# CITY OF WINTER PARK PLANNING AND ZONING BOARD

# Staff Report April 5, 2016

REQUEST OF WINTER PARK ELDERLY SERVICES, LLC FOR: CONDITIONAL USE APPROVAL TO BUILD A 48,650-SQUARE FOOT, THREE-STORY, 38-UNIT MEMORY CARE FACILITY AT 1298 HOWELL BRANCH ROAD, ZONED R-3.

||50336.00| 02.10.16 VILLA TUSCANY / Site + Landscape Plan // A-2

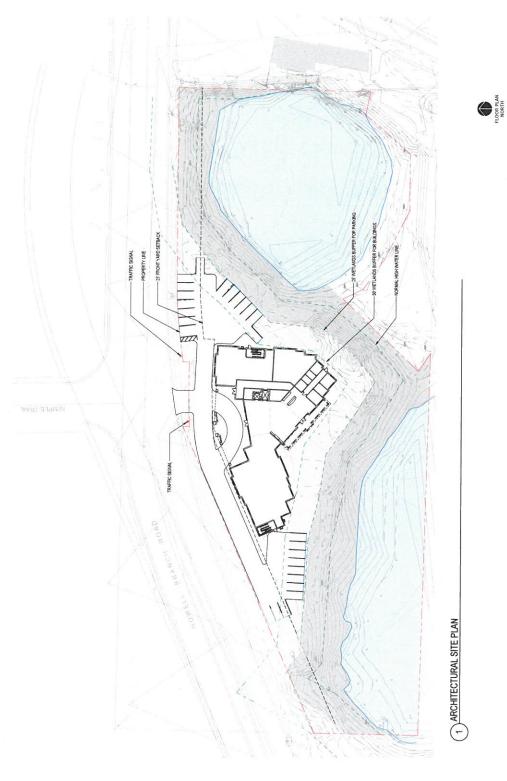
Parking and drives are shown on the plan accomodating 26 parking spaces, a front circular drop-off and access for service deliveries/dumpster pickup, etc. The project does not propose, at this time, any wall buffers but the staff expects that as part of the final conditional use approval, a perimeter wall along Howell Branch Road will be proposed to provide some buffer for privacy and traffic noise. The planning staff will be proposing a condition that will require a wall buffer for the parking that is visible to the residential properties to the south and west. The Zoning Code specifies that "to the extent practical, vehicles shall not be visible from the lake" While there will be many trees buffering the view of this project, a decorative five foot wall to the south and west sides will insure that the neighbors are not looking at cars in a parking lot or getting glare from windshield deflection. It also will serve as a buffer for headlights given the shift changes for the staff of this facility.

The applicant has submitted a landscape plan showing the trees to be removed and the trees proposed to be saved. The plan is based on a tree survey from 2004 so the sizes of the trees shown on the plans would be larger (with growth over 10 years) and also perhaps some others may have grown to the minimum nine inch protected category. This has been reviewed by Dru Dennison, the City's Urban Forestry Manager but she is unable to calculate the specific code implications until the tree survey is updated. The site has some larger older trees but otherwise the site is covered with 'pioneer' trees that have grown up over the last 30+ years.

On the whole, there are limited options to accommodate further preservation other than shown on the plan. The site layout covers the entire buildable area with either the building itself or the parking and drives. The plan shows removal of all the existing trees within that buildable area which total 65 protected trees (oaks, etc.) and 30 exempt trees (palm, rain, ear trees). The existing trees that are not within the buildable area of the property along the waterfront setbacks and such will be preserved and those account for 65 protected trees. Importantly, the trees to be saved along the waterfronts will help to buffer the view of this project from their residential neighbors.

- 2. That the project adds a five foot buffer wall to the south and west sides of the parking lot areas, in order to buffer the views of vehicles from the residential neighbors, to be approved in design and materials as part of the final conditional use review.
- 3. That if any new electric transformers/switch gear, generators or backflow preventers are required that they be located where not visible from a public street and shall also be landscaped so as to be effectively screened from view.
- 4. That any AC compressors are located or screened such that they are not visible from the neighboring residential properties.

(1) WEST ELEVATION

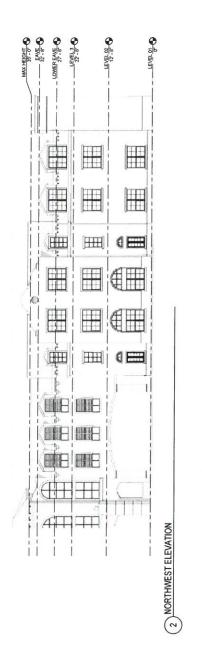
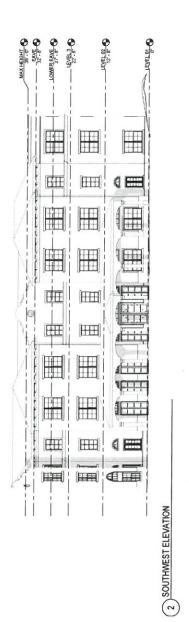
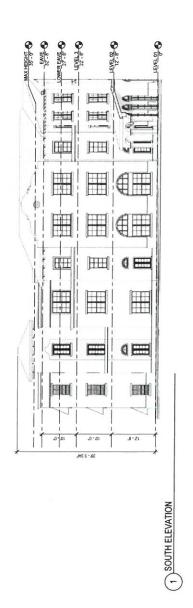
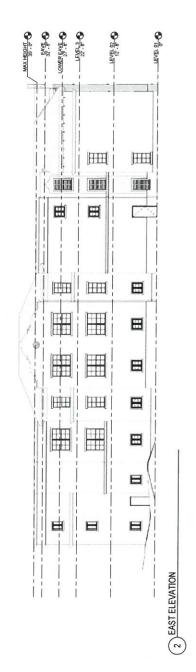
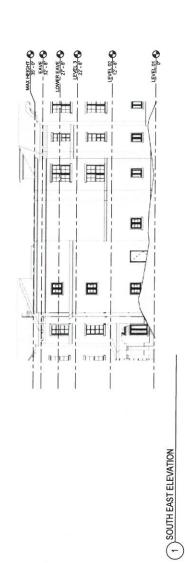
The main exception requested is to the required third floor roof slope and thus setbacks of the third floor of this project. Policy 1-3.8.6 from the Comprehensive Plan and as also incorporated in the R-3 Zoning states that "within areas designated medium density residential (R-3) (the project) shall not exceed two stories in height unless approved via conditional use by the City Commission. In addition, such third floors must be entirely contained within a sloping roof having a maximum 12:12 roof slope". In essence this requirement provides the appearance of a  $2\frac{1}{2}$  story building with dormer windows for the  $3^{rd}$  floor tucked into the roof slope versus a three story vertical wall building appearance.

The applicant is asking for an exception to the roof slope requirement (or setbacks for the third floor) in order to have more vertical walls that allow the units/rooms on the third floor to more closely match the size and orientation of the units/rooms on the second floor. The applicant believes their location is an important consideration to this request given the distance that this building will be away from other residential homes and the location adjacent to Howell Branch Road.

On the north side of this facility, facing Howell Branch Road with 30,600 cars a day and commercial properties across the street, the purpose of mitigating the visual appearance of 35 feet of building height has little purpose. However, on the south side of this facility facing the single family residential properties, mitigating the visual impact to be compatible is important. The City does not allow three story

single family homes. So while someone can build a 35 foot single family home, that height is typically accomplished with two stores of vertical wall and then a sloping roof to the 35 foot tall roof peak. To be compatible with the residential neighbors to the south, the third floor of this facility on the south side facing the single family homes should mimic that design characteristics via compliance with the code requirement for the sloping roof and dormers.

The problem with the current architectural design is that the  $2\frac{1}{2}$  story façade image is the one that faces Howell Branch Road and the full 3 story vertical wall façade image is the one that faces the neighborhoods. The images above show the view from Howell Branch Road. Portions of that façade have a dormer window image and the roof begins to slope back 27 ft.-6 inches sloping up to the 35 feet. However, in the images below, that is the south facing side there are vertical walls up to the 35 foot roof even and then roof slope or the Spanish mission style architectural detail that rise to 40+ feet in height. Thus the visible height to the neighbors is 40+ feet whereas if the dormer style on the street side was used exclusively the visual height would be 35 feet maximum with the top 7 feet sloping away, as a typical single family roof would do. Thus the applicant should reconsider these facades based on the appearance to the road and the neighbors.

The other Code exception requested is the un-dimensioned height of the roof slope and the Spanish mission style architectural detail which rises above the code height limit of 35 feet up to 40+ feet. If these architectural elements were only on the Howell Branch Road façade side, the staff would not be concerned but again they are consistent across the south facing facades.

1. That the project alter the exterior façade elevations facing residential properties to the south and west to comply with the intent of the Comp. Plan Policy 1-3.8.6 and with the 35 foot height limit and that the modifications be approved as part of the final conditional use review following customary notice to surrounding property owners.
